## Small Form Factor Special Interest Group

### MiniBlade™ Specification v1.0 (6 Mar 2009) Errata #1

PCB layout for right angle MiniBlade socket

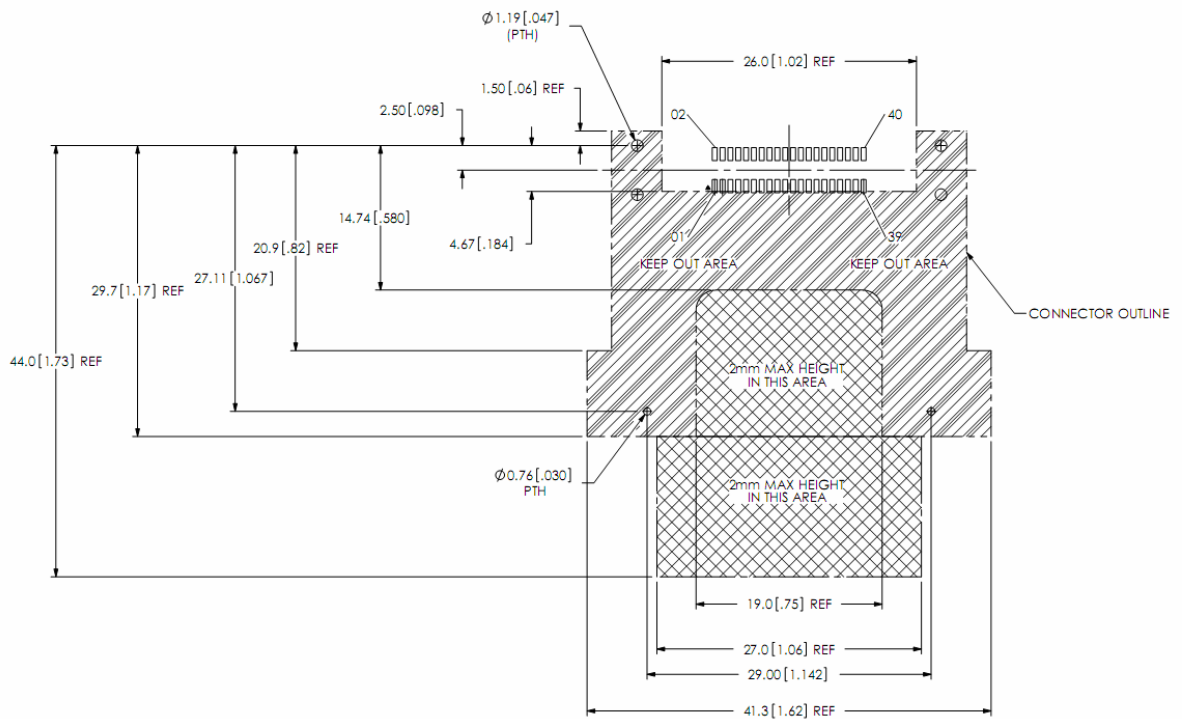
Appendix A, Page 18, PCB Layout for Right Angle MiniBlade Socket Drawing.

Incorrect pin numbers are called out in the drawing. The correct pin numbers are shown in the drawing below.
